Brake Fluid Flush
Voluntary Service Campaign

Reference: P8305
Date: March 22, 2018

Affected Models/Years:	Affected Population:	Dealer Inventory:	SERVICE COMM Activation date:	Stop Sale In Effect
MY2009 Murano (Z51)	88,662	NA	March 22, 2018	NO

BRAKE FLUID

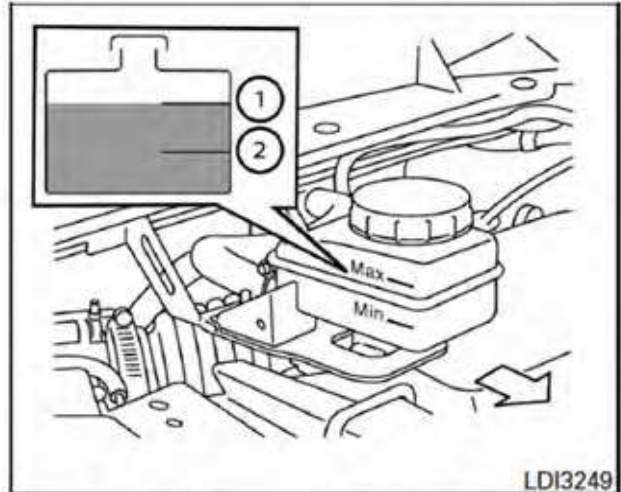
Check the fluid level in the reservoir. If the fluid is below the MIN line (2) or the brake warning light comes on, add Genuine NISSAN brake fluid CLARIANT 6M DOT4 or equivalent DOT4 up to the MAX line (1). If the fluid must be added frequently, the system should be checked by a NISSAN dealer.
